AGENDA

Grand Haven Charter Township Planning Commission

Monday, April 17, 2017 – 7:00 p.m.

DATE: April 13, 2017
TO: Planning Commission
FROM: Stacey Fedewa, Community Development Director
RE: Site Plan Review – Seavers Finishing – Parking Lot Expansion

SURVEY SHEET

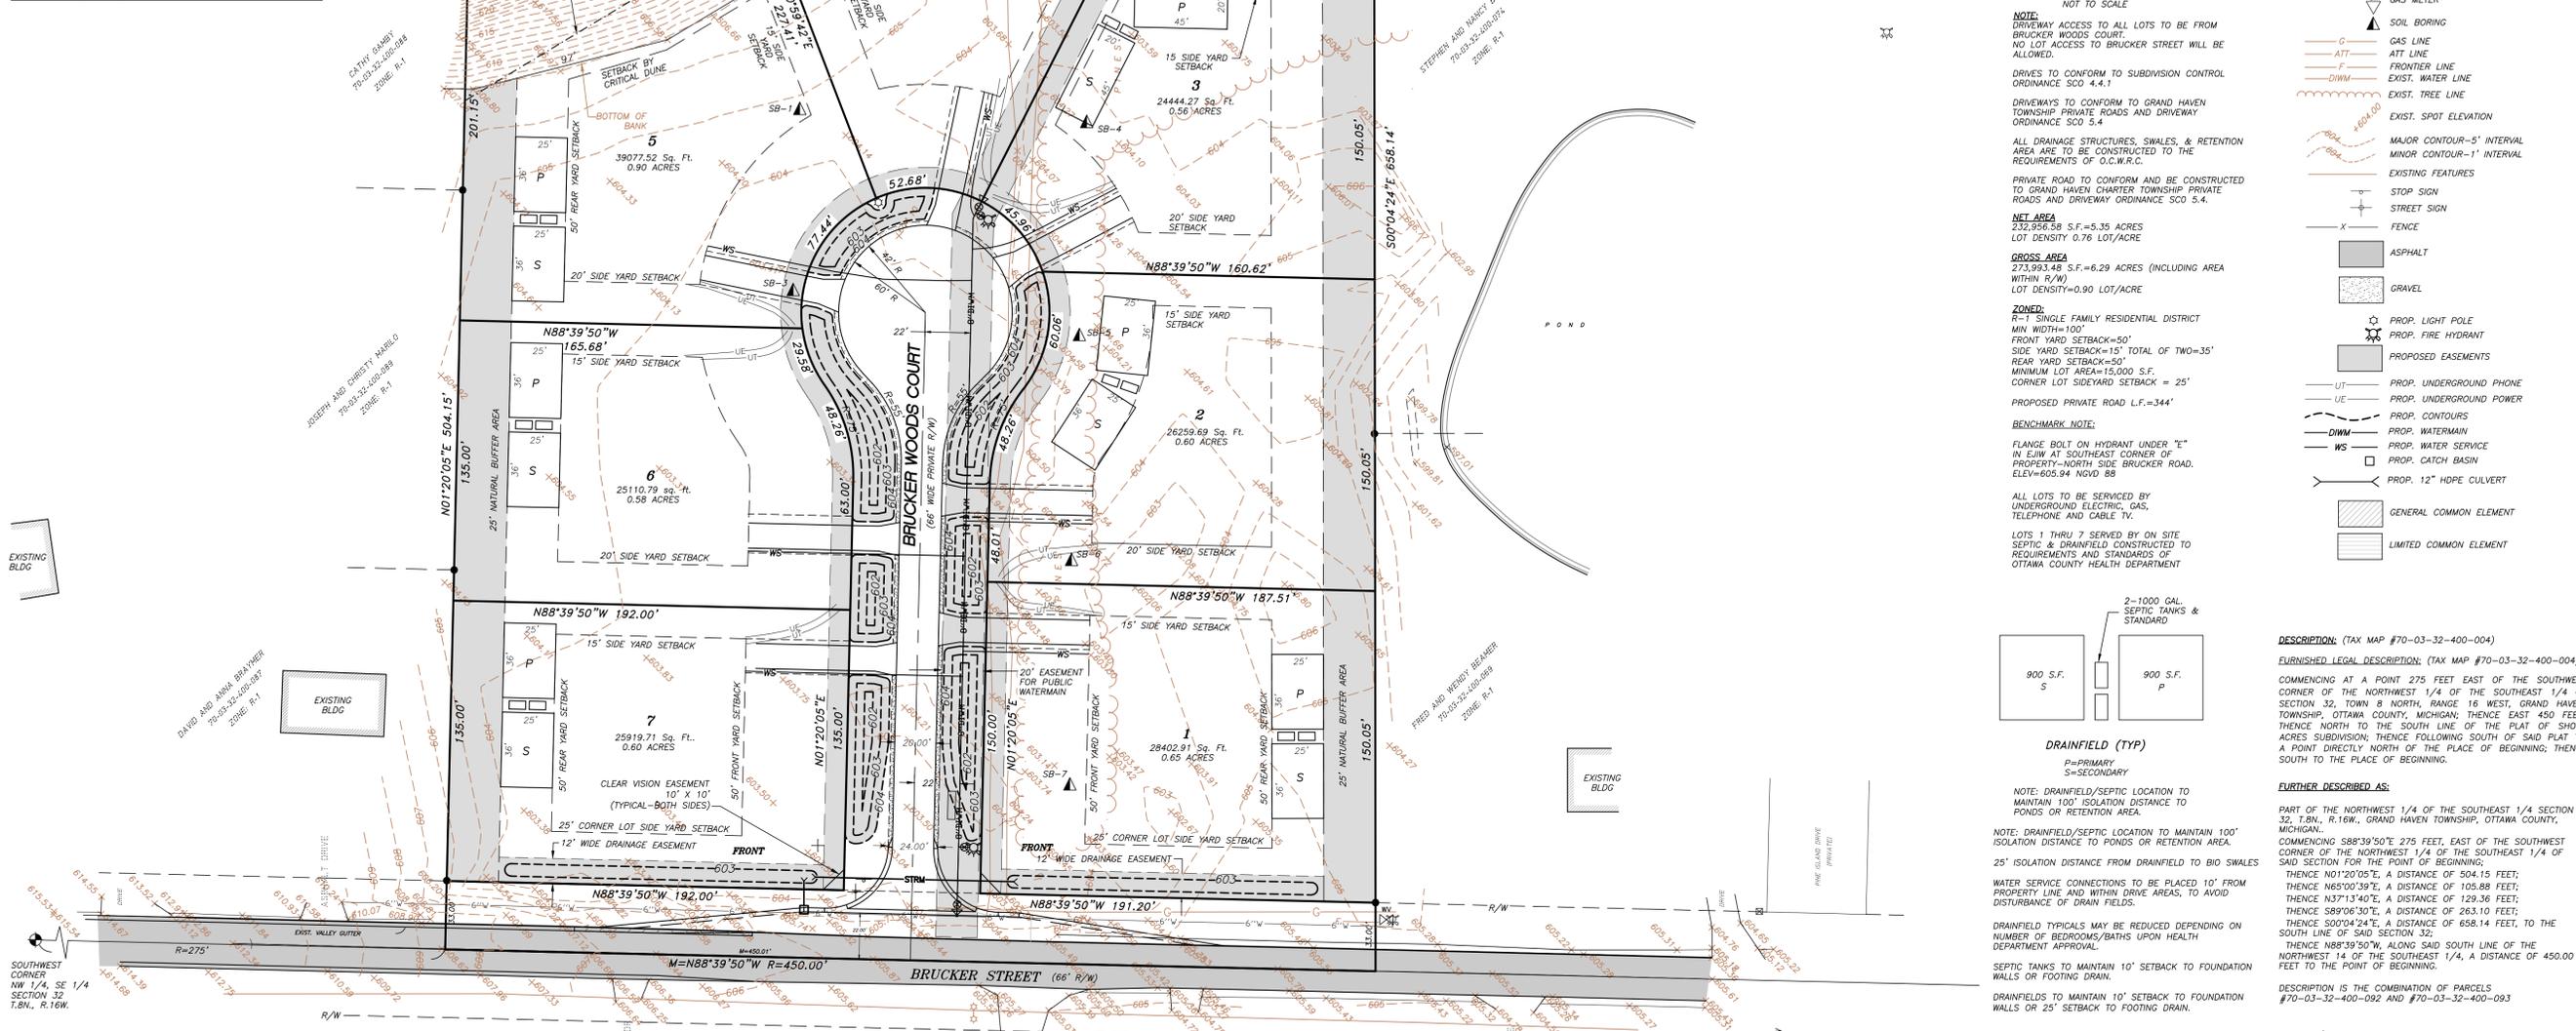
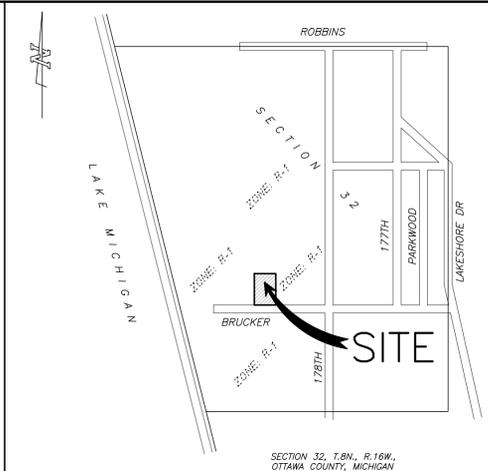
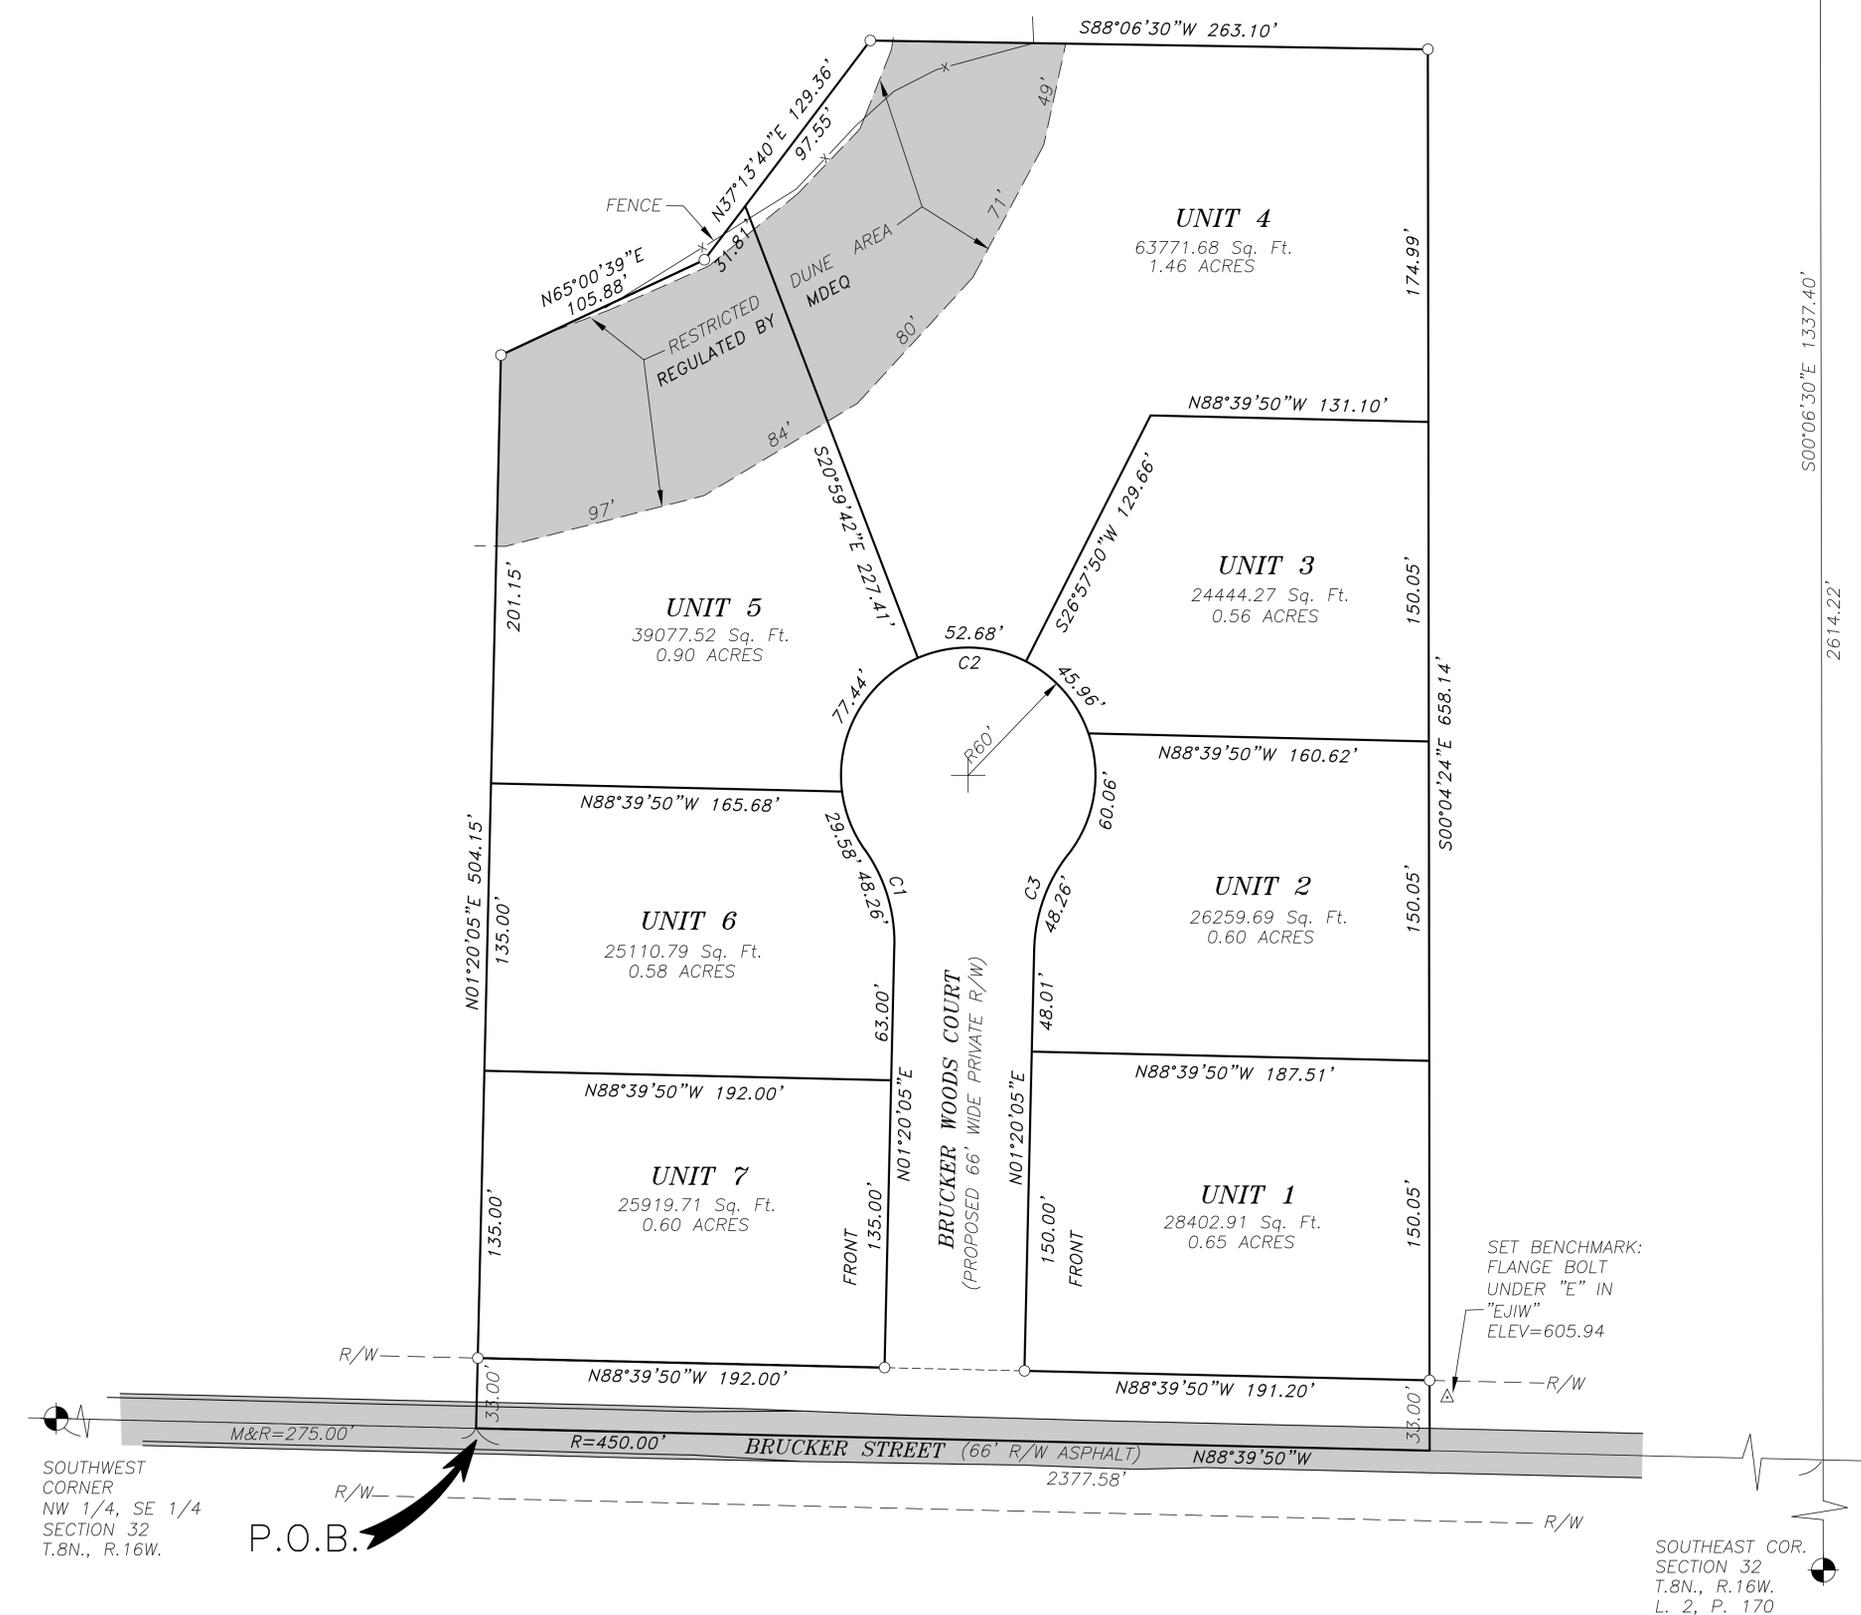
The revised site plan for Brucker Beach Woods has taken the bio-swales from outside the ROW to the inside of the ROW. As a public road this was not an option. Going private allows for this to occur. This is the only change to the plan. OCRC and Water Resources have reviewed plan to ensure that it meets all their requirements. This will allow a better development as more trees can be saved thus creating to more private feel/character which is more consistent with the neighborhood.

Sheet 1: Cover sheet – no changes other than date and road name

Sheet 2: Survey Plan – change the word public to private on road.

- change date
- change road name to Brucker Woods Court

Sheet 3: Site Plan & Cross Section – change the word public to private (on road and in notes)

- change date
- change road name to Brucker Woods Court

Sheet 4: Utility Plan – change the word public to private (on road and in notes)

- change date
- change road name to Brucker Woods Court
